MBHP_OPL3 module modifications, the 5V option

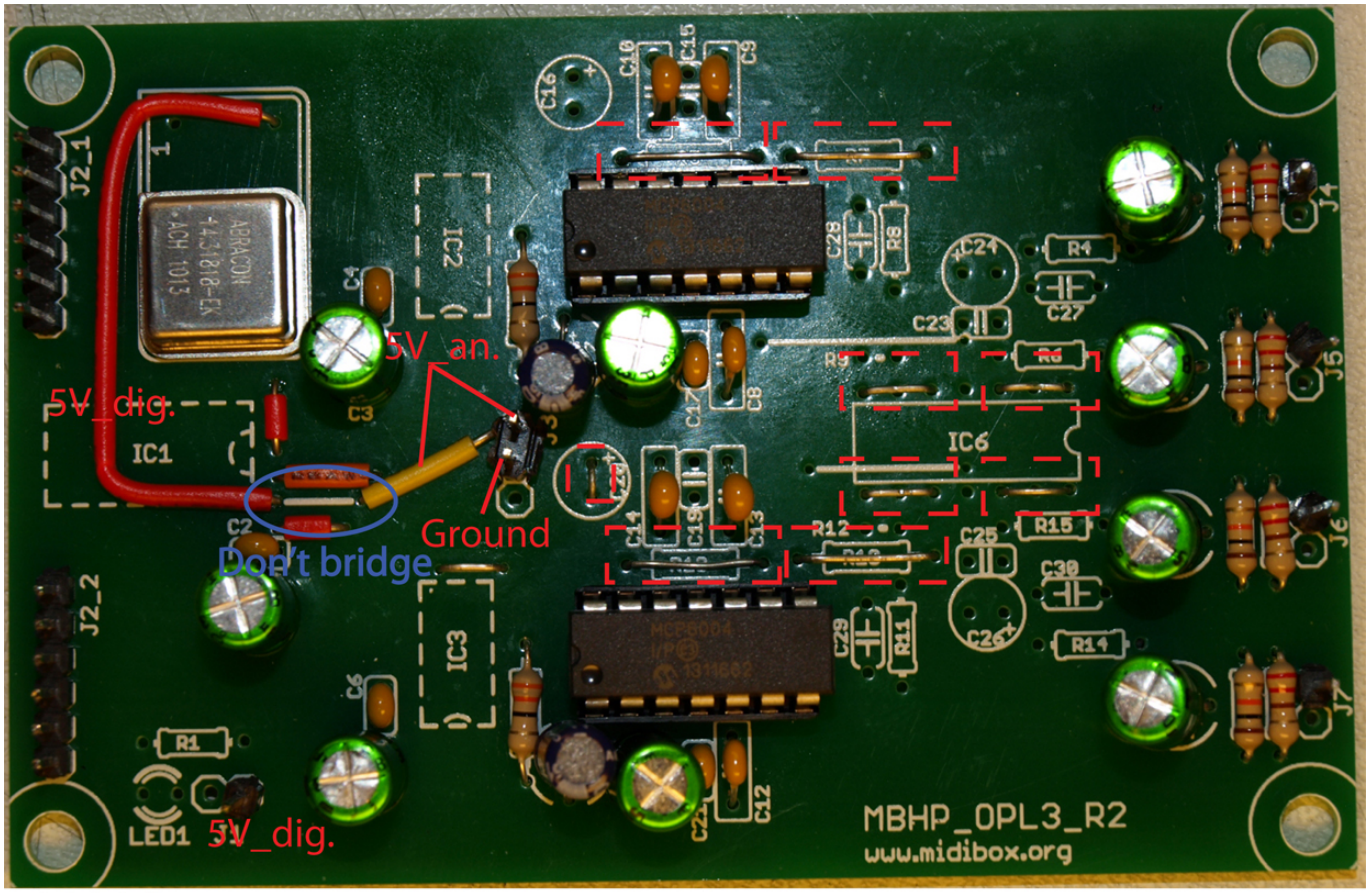
- Replace R5,R7,R10 and R13 with jumpers
- Bridge IC6 pads 1&3, 5&7, 8&10 and 12&14
- Leave out:
IC6
R4, R6, R8, R9, R11, R12, R14, R15
C15, C16, C19, C20, C23-C30
- Bridge C20 pads (to supply Ground for the op-amps)
- Leave out bridges to IC6
- Use MCP6004 for IC3 and IC5
- Supply 5V to the +12V pin, and Ground to Ground

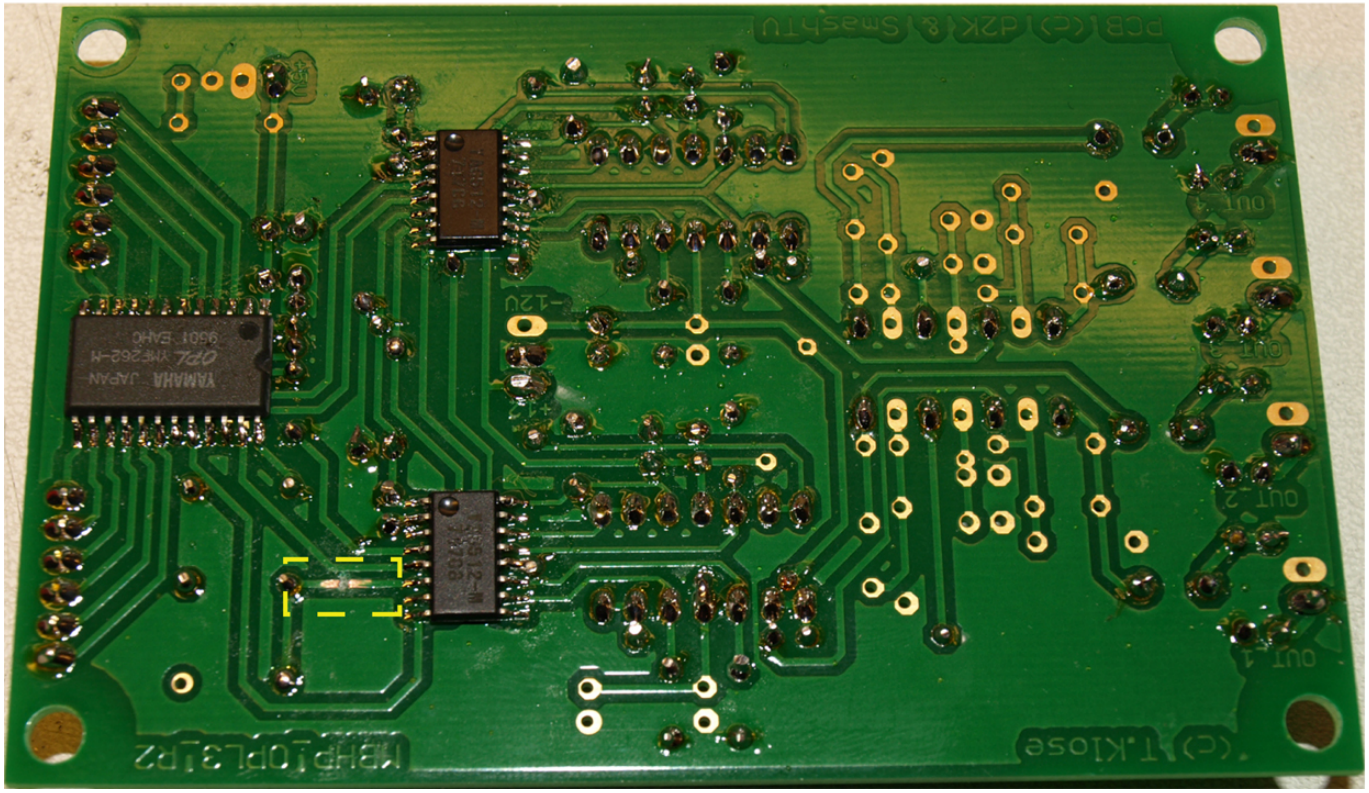
- Cut the trace between the 5V pin of the Oscillator and the DAC
- Leave out the middle horizontal bridge from IC1
- Connect the right pad of this bridge to the 5V pin in the middle of the board with a jumper
- Connect the left pad of this bridge to the 5V pin of the Oscillator with a jumper

Bridge

Cut trace
